NOV_SCE ATJ_20220405-01

NOTICE OF VIOLATION

Energy Safety Inspection Report

Report Name: SCE_ATJ_ 20220405-01

Structure ID: 4541503E

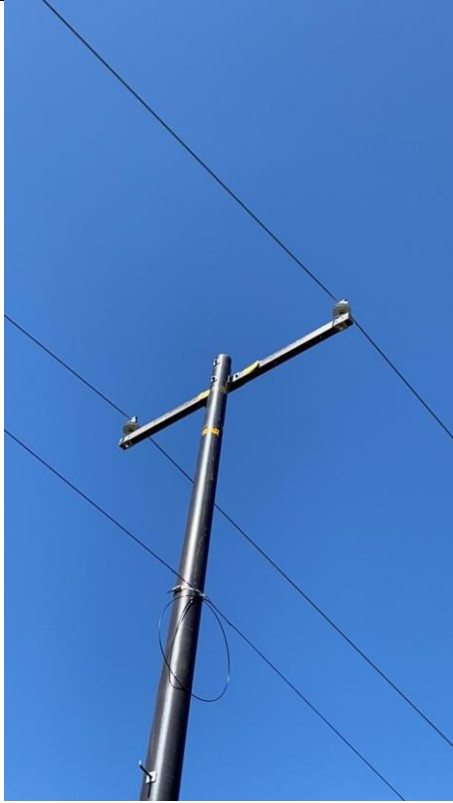
Item1IA1mg1: No vibration dampers

Structure ID: 4465113E

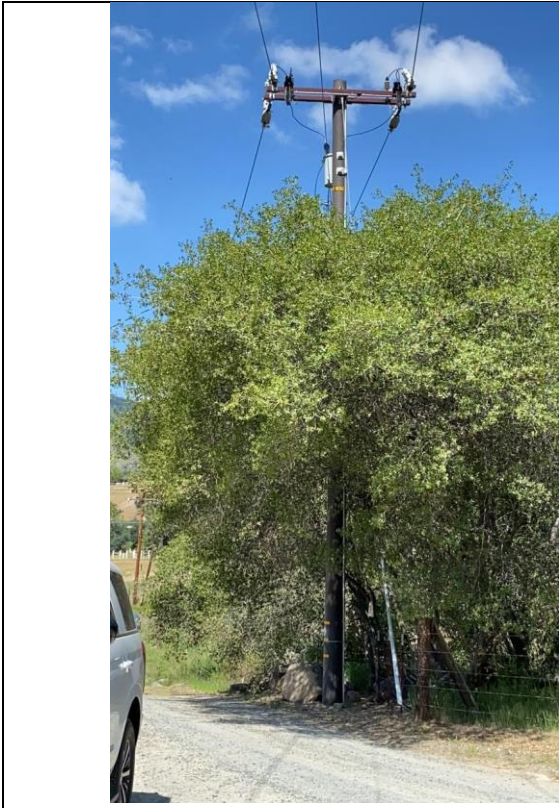
Item2IA1Img1: No vibration dampers on span
